## SUBMITTAL REVIEW COMMENTS

Date: 4/17/18  
Owner: Northwest Seaport Alliance  
Project: West Sitcum Stormwater Treatment  
Contractor: BioClean

Submittal Title: Modular Wetlands  
Submittal Number: Quote 1918026WQ1  
Reviewer: C. Simmons  
Review: Make Corrections Noted

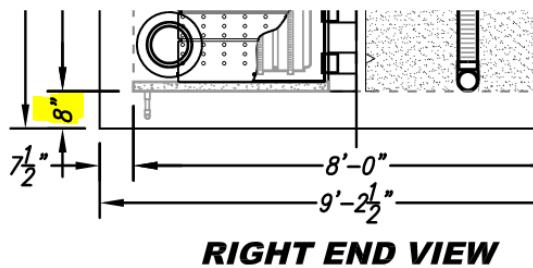
1. Sheet A2.4, Plan View, dimension 3'-6" from centerline of pipe out to exterior edge of pre-cast is incorrect. The value should be 4'-6", see Basin A penetration spreadsheet already provided.

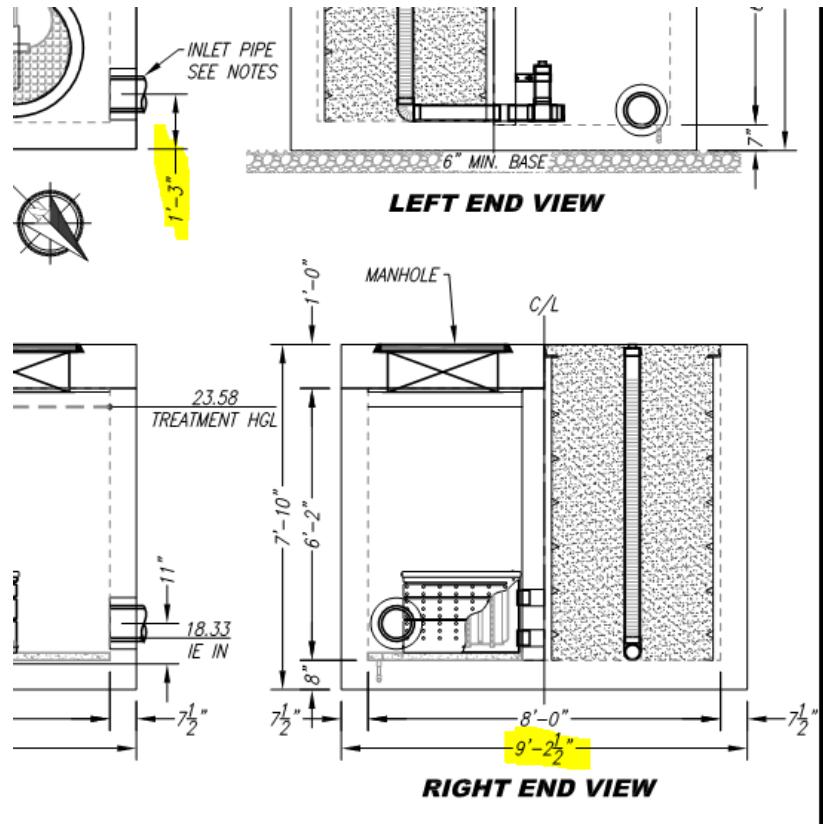
2. Sheet B1.3, Elevation View, dimension 4" from centerline of pipe out to IE out is correct. Please note that this dimension may not have been indicated in the information previously provided.
3. Sheet C1.1, Right End View, dimension 8" from pre-filter cartridge bottom to exterior bottom of pre-cast indicates 8". Spreadsheet says 7". Please confirm why this has changed.

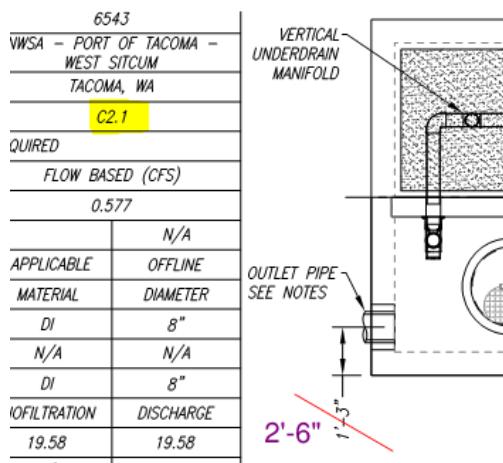
4. Sheet C1.1, Right End View, dimension 9'-2.5" has changed from 9'-3". This change carries over to the Plan View dimension of centerline of inlet pipe to exterior wall of pre-cast. The provided spreadsheet indicates the dimension of 8'-0" from centerline of inlet pipe to the other exterior wall.  $8'-0" + 1'-3" = 9'-3"$  not 9'-2.5". Please advise.
